# Energy Storage Resources: ICAP Manual Changes

**ICAPWG/MIWG**

December 5, 2019

## Attachment J

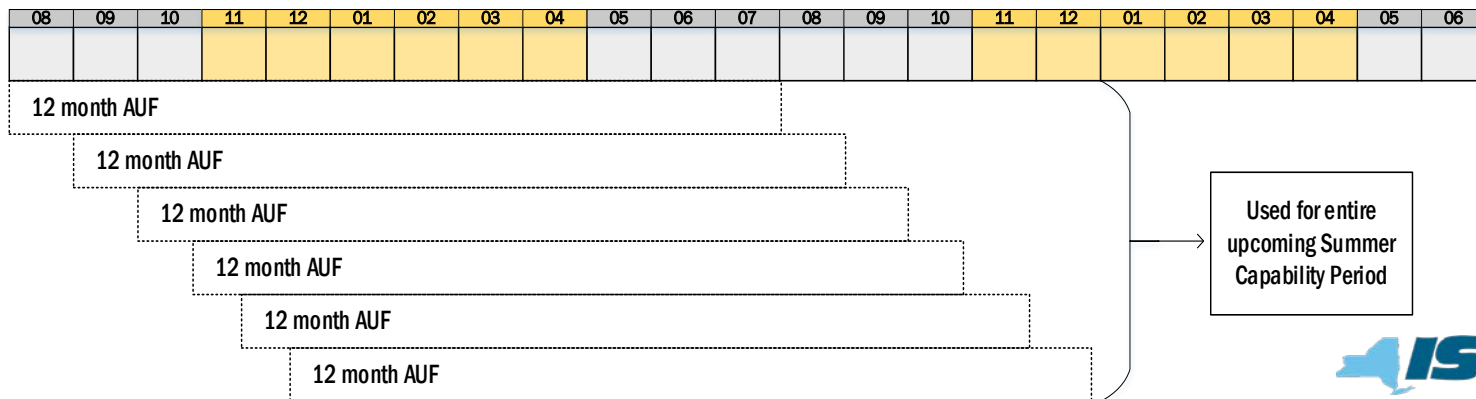
- **Attachment J – Unforced Capacity for Installed Capacity Suppliers**
  - Section 3.7 includes revisions to the procedure for calculating Unforced Capacity values for Energy Storage Resources
    - Two additional parameters were added to the “Total Available ICAP Seconds” equation to more accurately measure the availability of the storage asset has in the Real-Time Market
      - Energy Level Availability
        - » Measure the ratio of the Resource’s real-time Energy Level to the sum of its DAM Energy and Reserves schedule
      - LOL Availability
        - » Measure the ratio of the Resource’s real-time LOL to the negative ICAP equivalent of UCAP sold
    - Additional terms have been added to Section 3.7 to elaborate on the Energy Level Availability and LOL Availability equations
